Project	IEEE 802.16 Broadband Wireless Access Working Group < http://ieee802.org/16 >
Title	PEAP Clarification
Date Submitted	2005-03-1016
Source(s)	JUNHYUK SONG, JICHEOL LEE, YONG CHANG Voice: +82-31-279-3639 Samsung Electronics junhyuk.song@samsung.com
Re:	Re: IEEE P802.16e/D5a
Abstract	PEAP Clarification
Purpose	Discuss and Adopt as the baseline text
Notice	This document has been prepared to assist IEEE 802.16. It is offered as a basis for discussion and is not binding on the contributing individual(s) or organization(s). The material in this document is subject to change in form and content after further study. The contributor(s) reserve(s) the right to add, amend or withdraw material contained herein.
Release	The contributor grants a free, irrevocable license to the IEEE to incorporate material contained in this contribution, and any modifications thereof, in the creation of an IEEE Standards publication; to copyright in the IEEE's name any IEEE Standards publication even though it may include portions of this contribution; and at the IEEE's sole discretion to permit others to reproduce in whole or in part the resulting IEEE Standards publication. The contributor also acknowle

Figure 133—AK with EAP only authentication

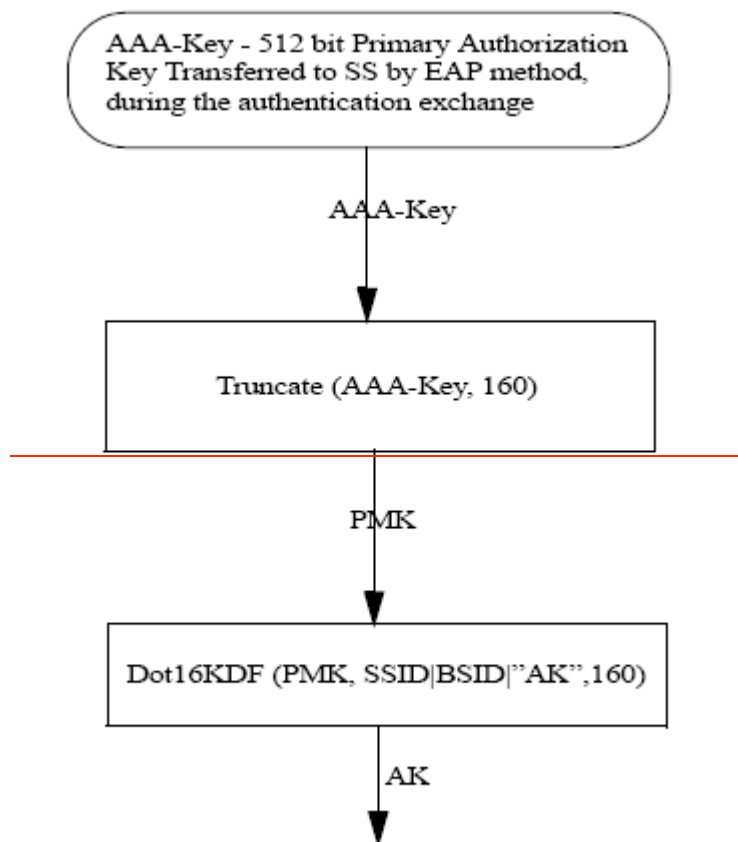
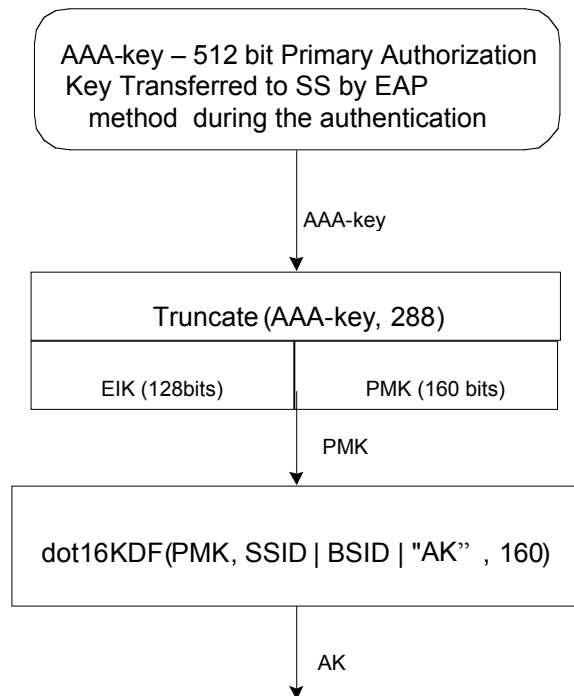
The product of the EAP exchange which is transferred to 802.16 layer is the AAA-key. This key is derived (or may be equivalent to the 512-bits Master Session Key (MSK)). This key is known to the AAA server, to the Authenticator* (transferred from AAA server) and to the MS. The MS and the authenticator derive a PMK (Pairwise Master Key) [and optional EIK](#) by truncating the AAA-key ~~after~~ [to 288+60](#) bits.

[EIK](#)|PMK = truncate (AAA-key, [288+60](#))

[Change Figure 133]

[Figure 133-AK with EAP only authentication](#)
